SUBSURFACE WASTEWATER DISPOSAL SYSTEM APPLICATION

City, Town, or Plantation: **AUGUSTA**
Street or Road: **BELGRADE ROAD**
Subdivision, Lot #: **CIVIC CENTER DRIVE APARTMENTS**

SIDNEY H. GELLER TRUST
SITE PLAN - BUILDING #2 SEPTIC
CIVIC CENTER DRIVE APARTMENTS
BELGRADE ROAD
AUGUSTA, MAINE

From: Steve Howell [SHowell@SWCole.com]
Sent: Friday, December 04, 2009 9:09 AM
To: George Soucy Jr.
Cc: Tim Hodgins
Subject: Emailing: Scan9221

CROSS SECTIONS - BUILDING #2 SEPTIC

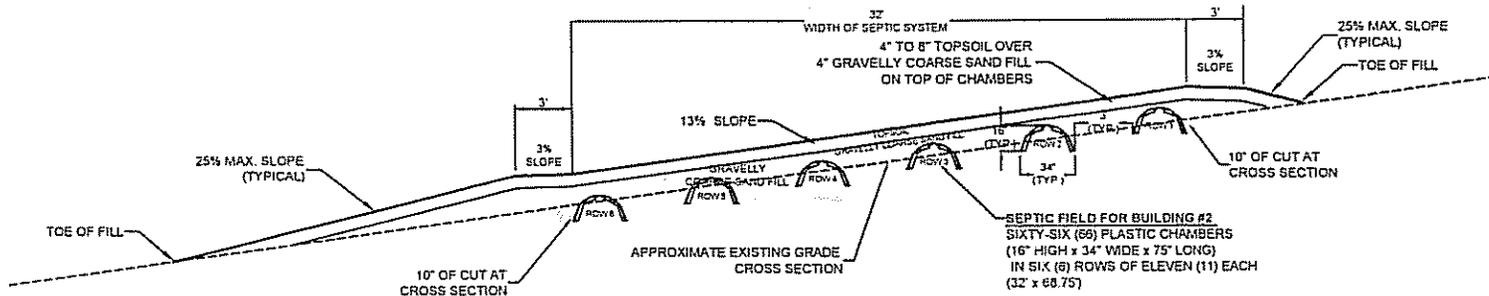
We were contacted by the contractor (McGee Construction) installing the 3 septic systems for Civic Center Drive regarding installation of A300 Zabel filters on the existing septic tanks. The contractor has determined that the existing tanks will not accommodate the A300 filter and that the tanks have the old-fashioned top of the tank hanging baffles. He is requesting that we eliminate the requirement for the A300 filter on the existing tanks. We feel this top hanging type of baffle will be effective at eliminating solids from the effluent and have agreed to eliminate the A300 filter requirement unless the existing tank or baffle is in poor condition and needs to be replaced.

Attached is a copy of page 1 for the three septic designs and the revised construction note page. Please let me know if you have any concerns or recommendations regarding this revision.
